PROPOSED RESIDENCE AT:

325 VIA LINDA

ARCOM # ARC-24-074

MAT-O.1

PROPOSED PERSPECTIVE - ENTRY AXIS, MOTOR COURT AND GARAGES

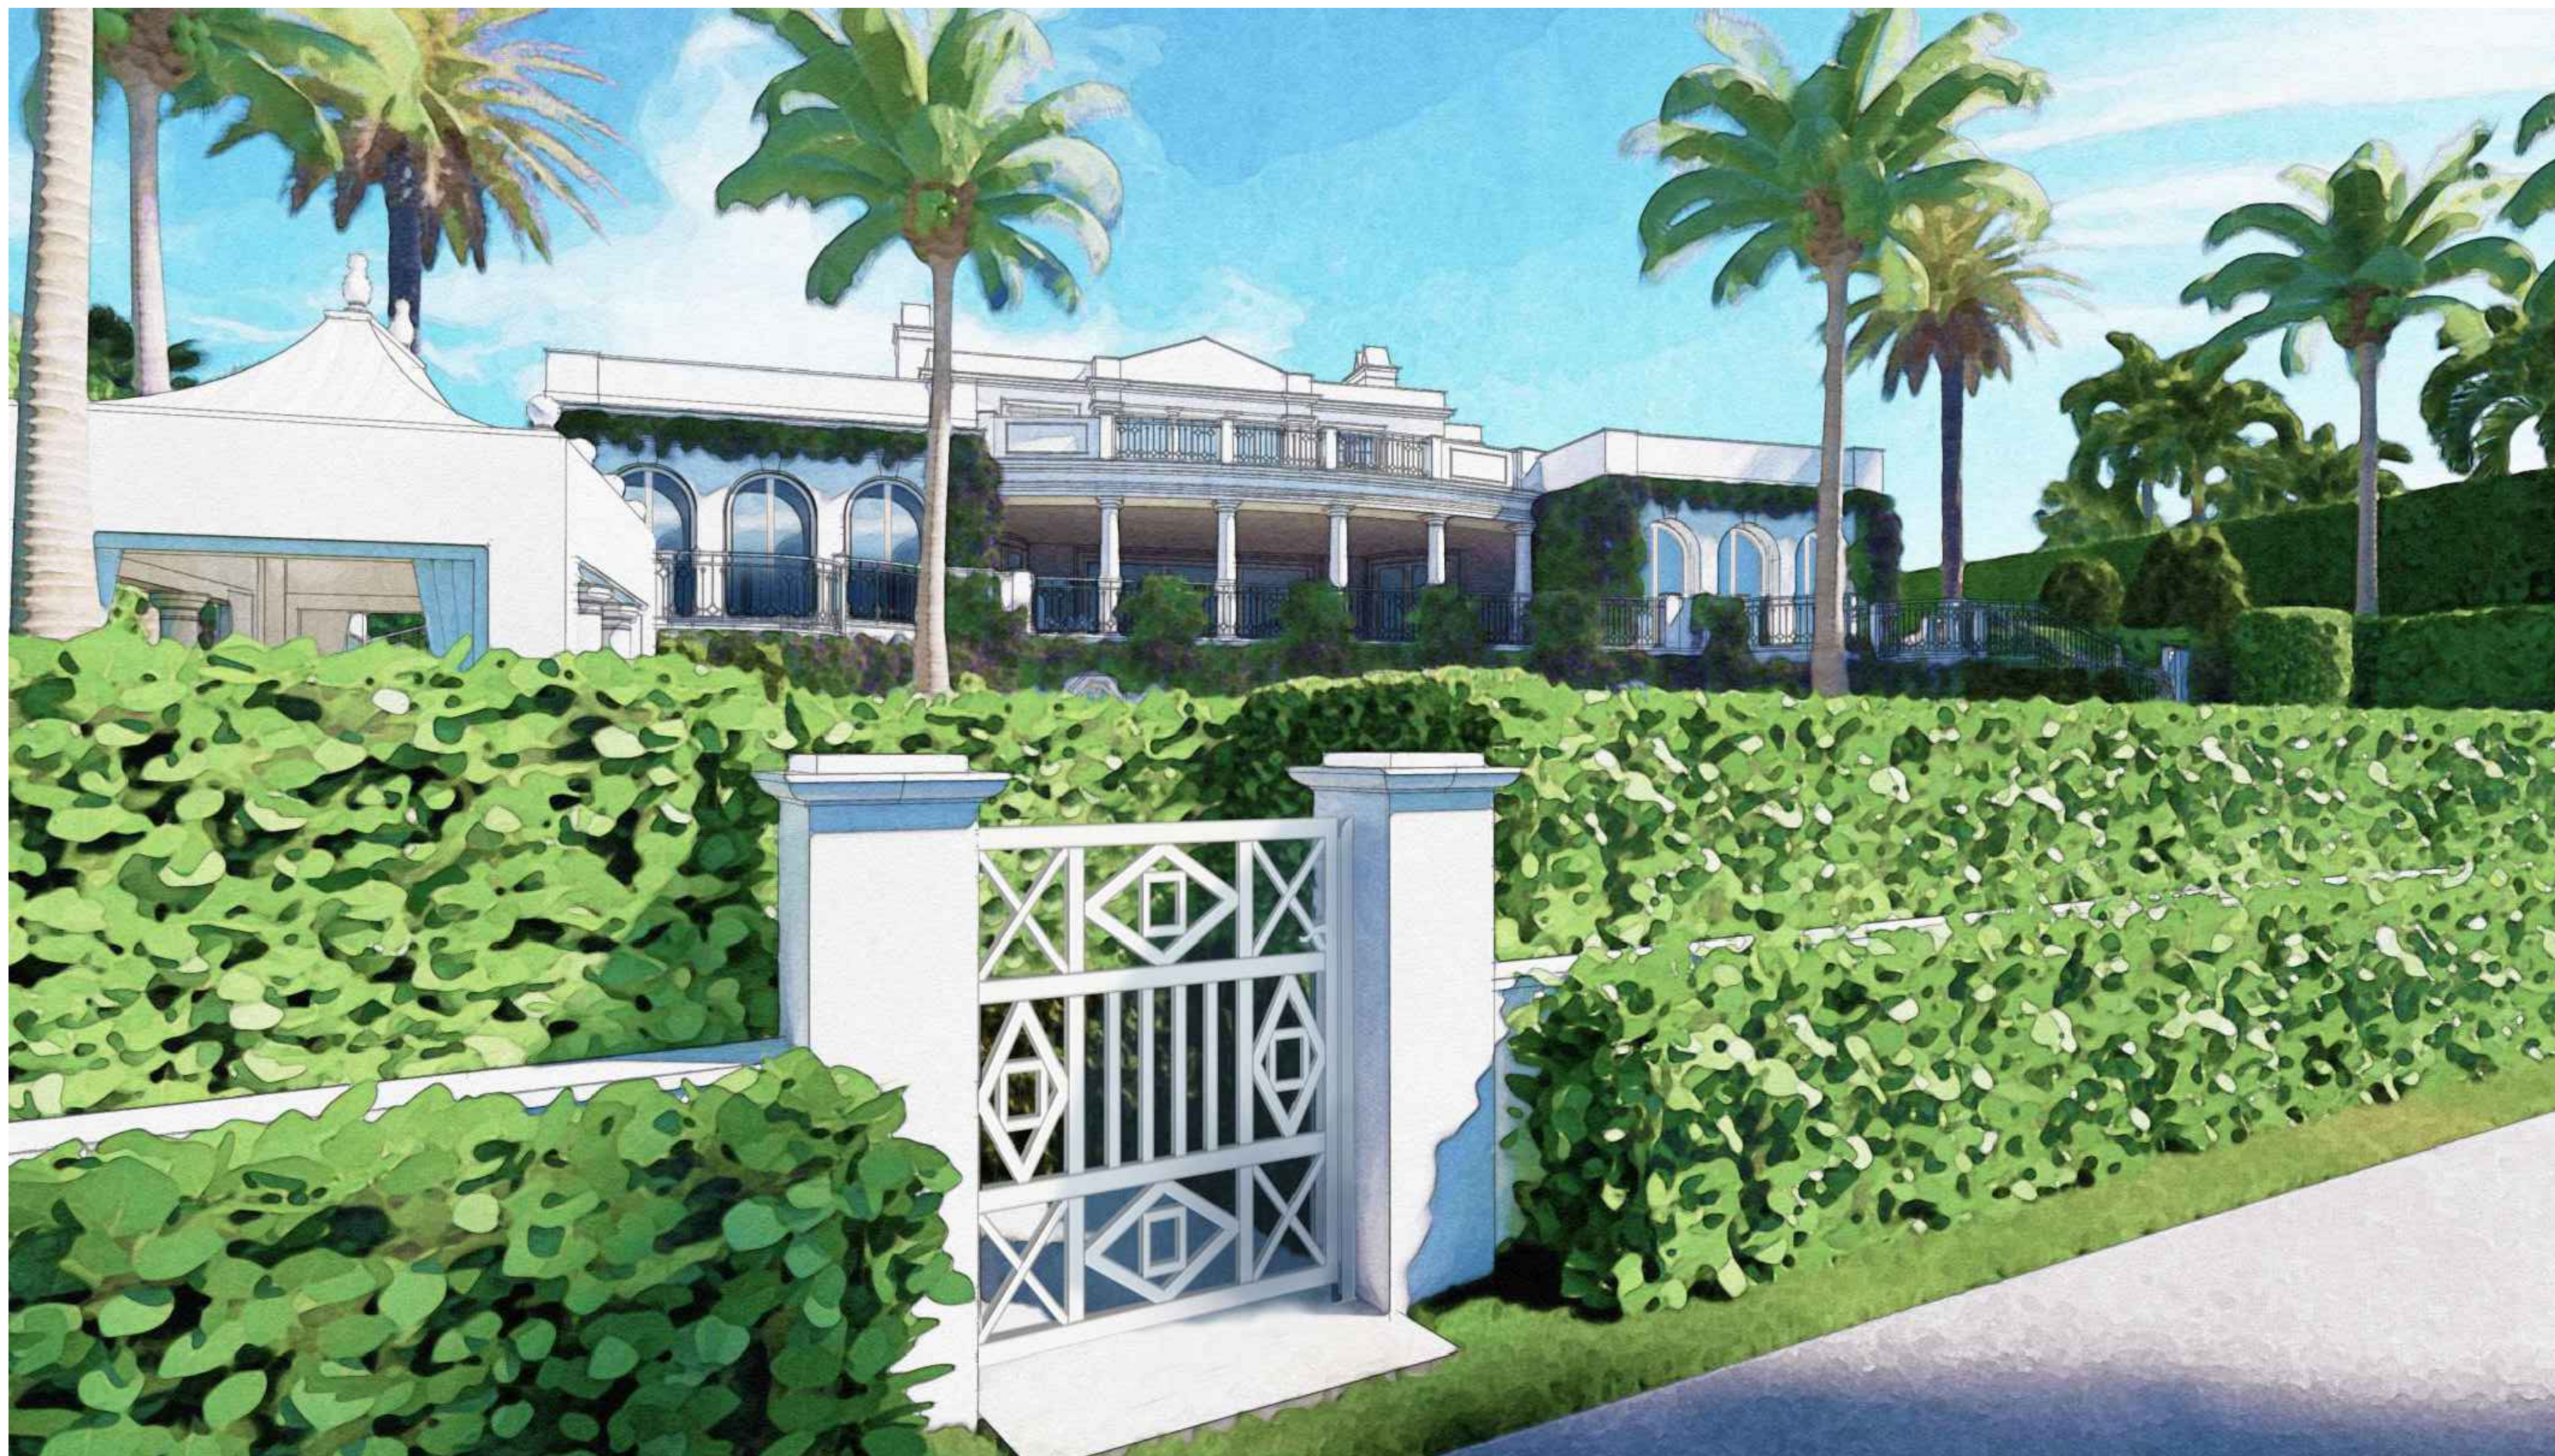
- REVISIONS
- EXTERIOR DOORS AND WINDOWS - PAINTED WHITE, IN LIEU OF BRONZE
 - ENTRY DOORS - REVISE THE DESIGN AND ADD SIDELITES

PROPOSED - SOUTH ELEVATION FROM VIA LINDA

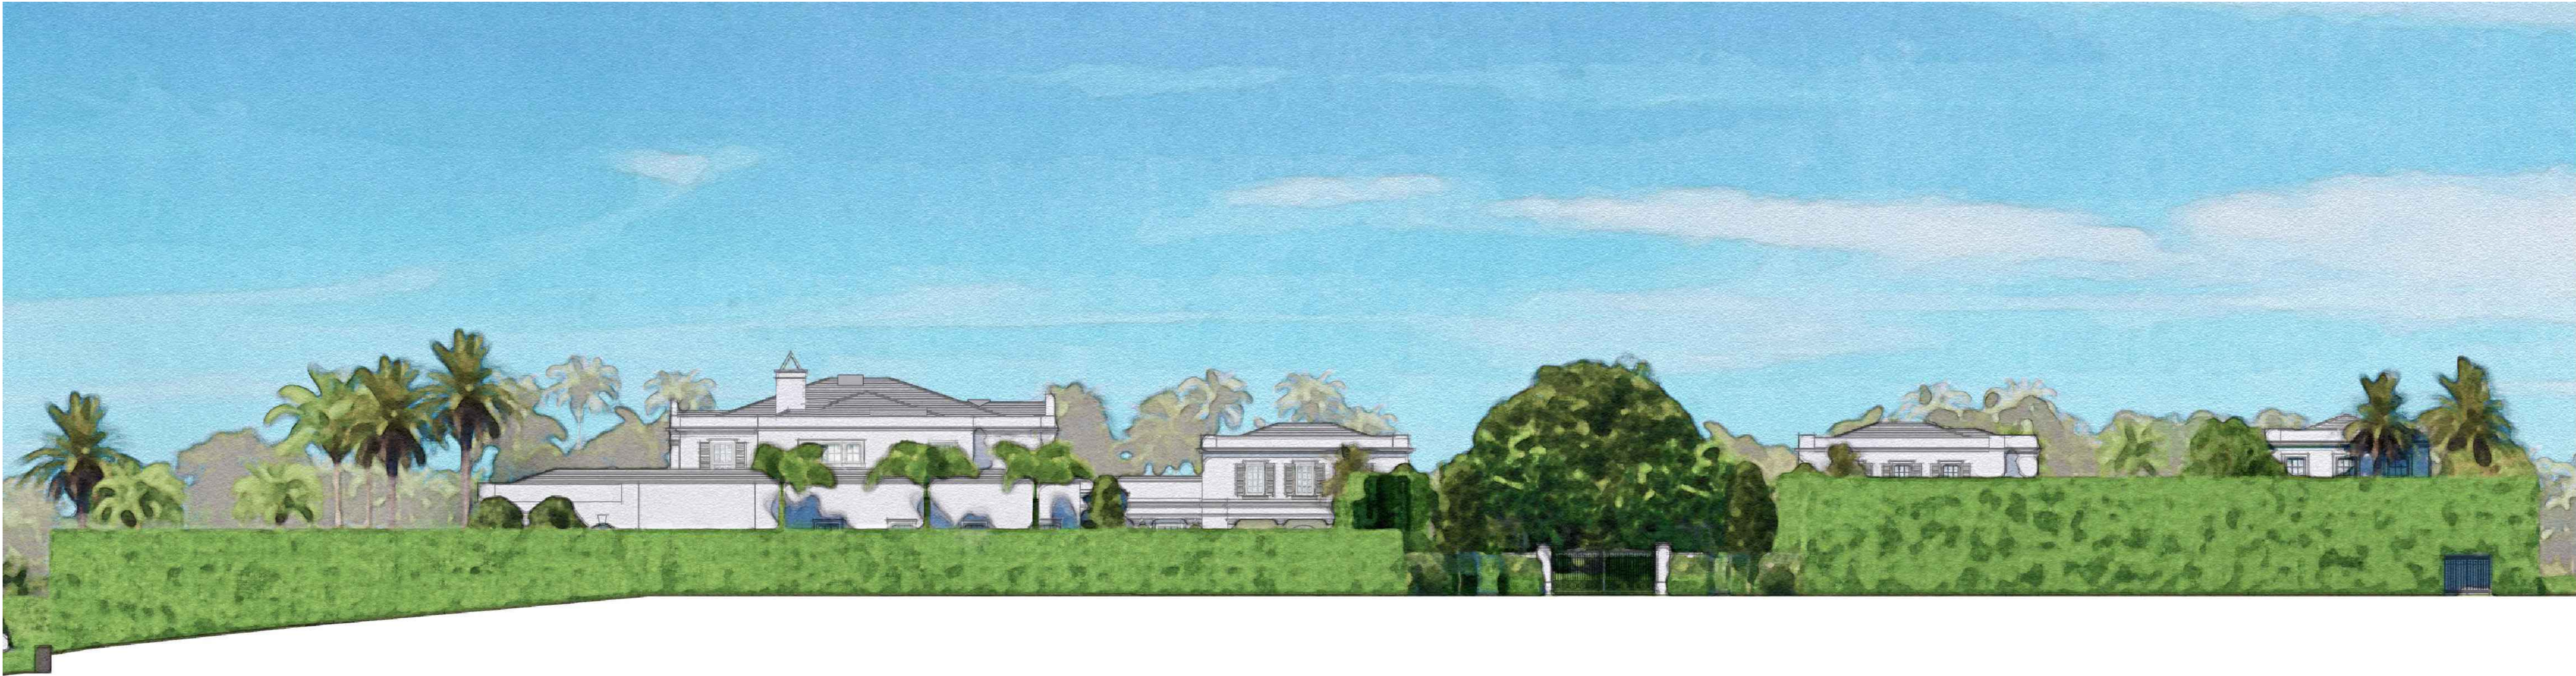
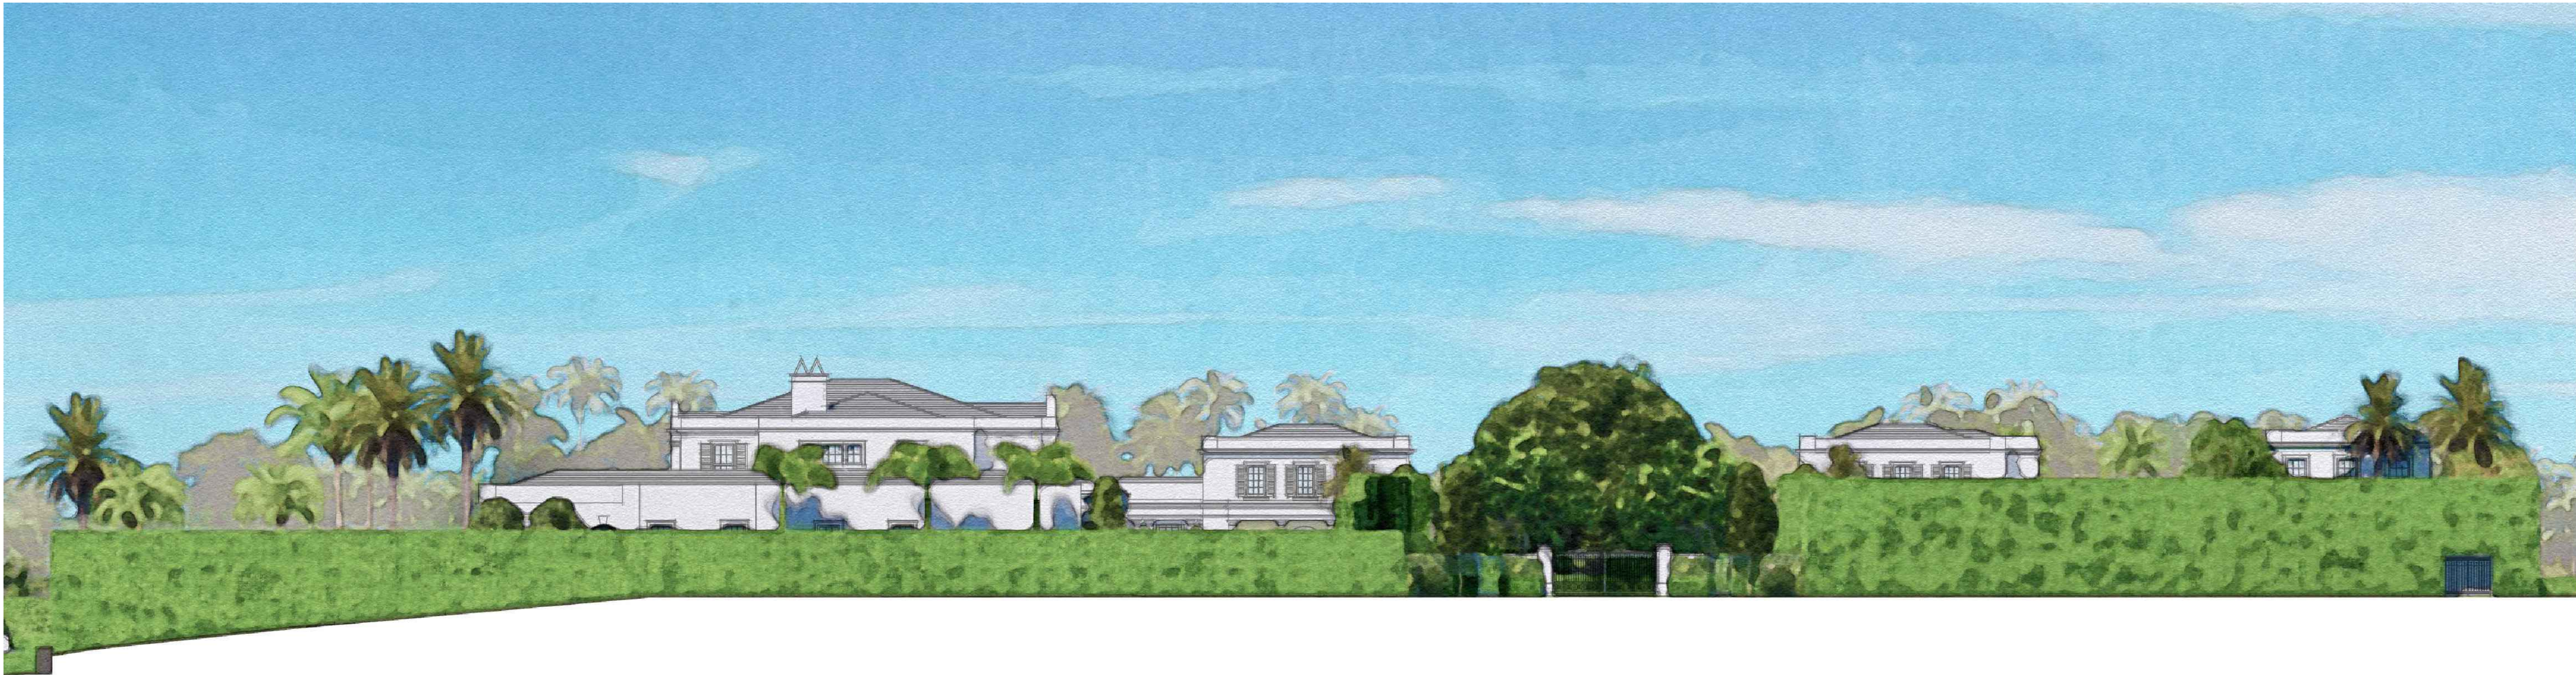
- EXTERIOR DOORS AND WINDOWS - PAINTED WHITE, IN LIEU OF BRONZE
- PROPOSED SKYLIGHTS AT MAIN HOUSE ROOF AND SHIFT THE CHIMNEY WEST TO ACCOMMODATE TWO OF THE FOUR SKYLIGHTS
- FLAT ROOF AT MAIN HOUSE, BEYOND THE PARAPET FOR THE ELEVATOR

PROPOSED
EAST ELEVATION - MAIN HOUSE

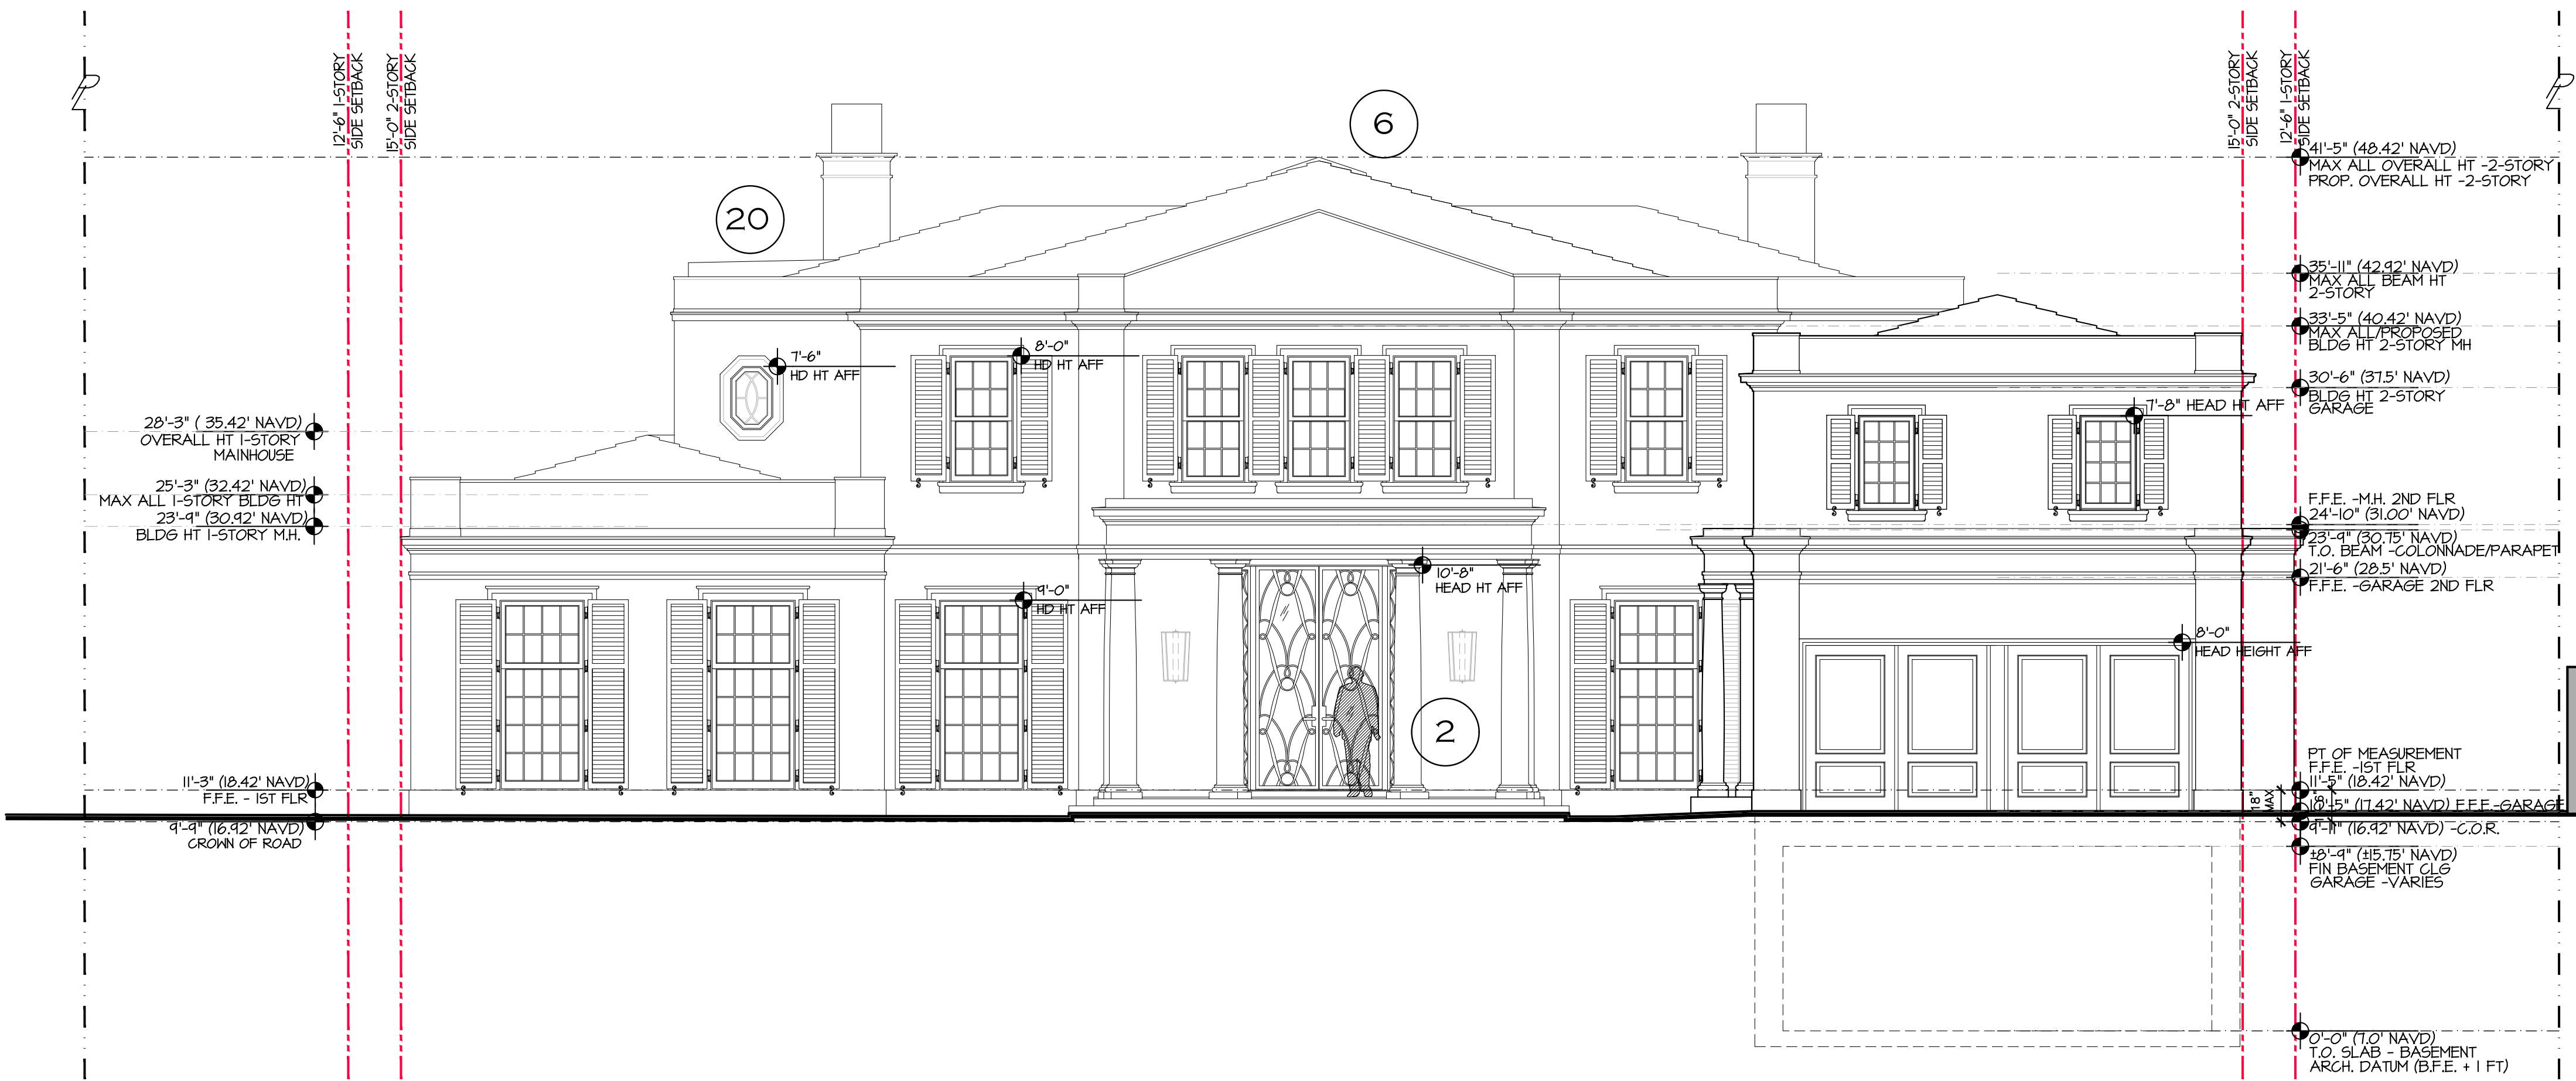
1. TYPICAL DOORS AND WINDOWS REVISED TO IMPACT RATED WOOD FENESTRATIONS, PAINTED WHITE IN LIEU OF BRONZE.
2. ENTRY DOOR, ADDING SIDELITES AND MODIFIED DESIGN, REMAINS BRONZE AND GLASS.
6. ROOF - (4) SKYLIGHTS PROPOSED, SEE ROOF PLAN FOR EXTENTS.

20. OWNER'S REQUEST FOR A COMMERCIAL ELEVATOR WHICH REQUIRES ADDITIONAL HEIGHT, SEE ROOF PLAN FOR EXTENTS.
